HORSHAM DISTRICT COUNCIL CONSULTATION

TO:	Horsham District Council – Planning Dept
LOCATION:	Barns Green Stores Chapel Road Barns Green Horsham
DESCRIPTION:	Application for Approval of Details Reserved by Condition 5 and 6 to approved application DC/19/2052
REFERENCE:	DISC/24/0288
RE-CONSULT:	1st set of comments in black 2nd set of comments in blue 3rd set of comments in green 4th set of comments in purple
RECOMMENDATION:	More Information More Information More Information Advice

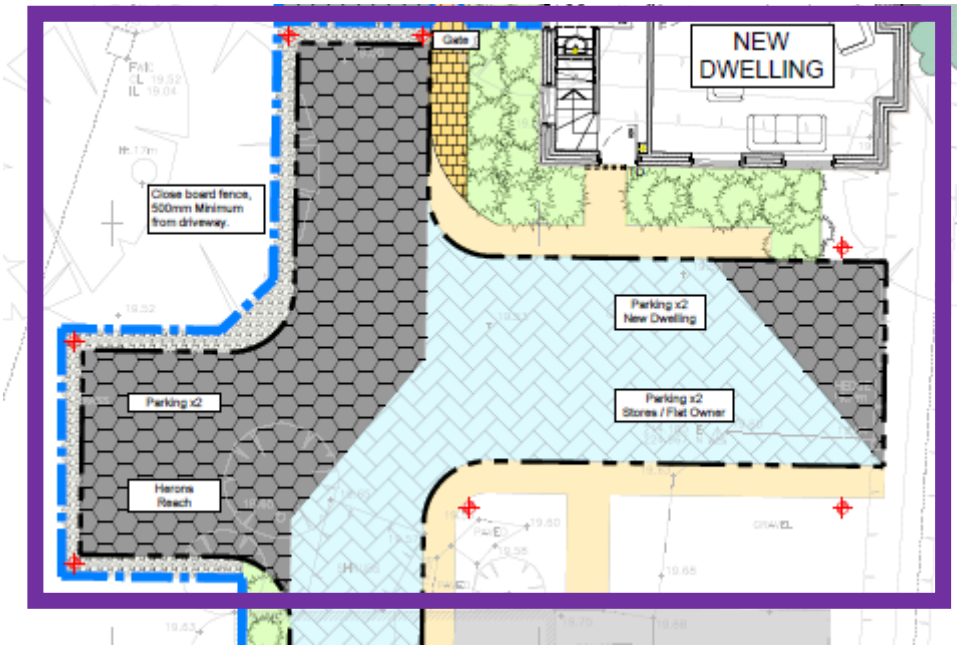
We note now, however, that the desired layout of limestone chippings (no-dig) and permeable paving may look unsightly, therefore we would advise that the area within the purple box below is proposed as a uniform permeable surface that can be installed as a 'no dig' paving system. At minimum, we recommend achieving a uniform appearance by ensuring that the colour palette for the proposed treatments are similar or matching. In addition, the no dig area should extend to the western boundary in order to protect the RPA of TPO'd T5.

Amended, with thanks. Closed.
